PR440FX Motherboard Specification Update

Release Date: November 1998

Order Number: 281832-012

1. Relocation of Mounting Hole on Motherboard Dimension Figure

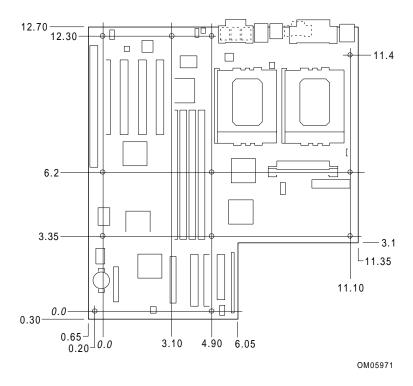
Figure 2, Motherboard Dimensions, will be replaced with the following figure:
